Your Ref: 18/00825/HYBRID

The new plans (P16-0631_08AI Composite Parameter Plan) seem to have removed the 177m exclusion zone around the Sewage Treatment plant. As you can see below the old plans are on the left and the latest on the right

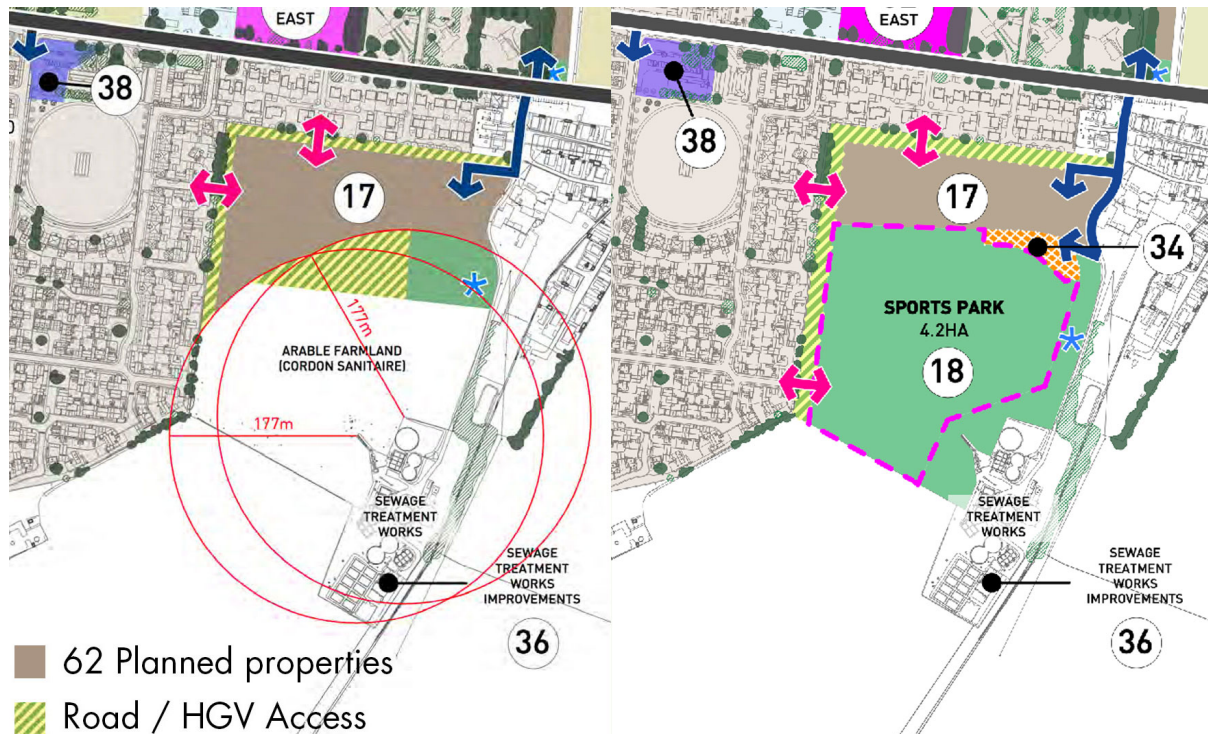
The exclusion zone is there for the safety and wellbeing of the people who live and play in that zone. By blatantly ignoring it, you are likely to induce a health risk for the people who use the Sports Park. Can we remind you of the Anglian Water Risk Assessment for Sewage Treatment Works (attached). For a village of

2500 – 5000 residents, they recommend keeping proposed development 250m away from the STW to avoid a medium risk of odour.
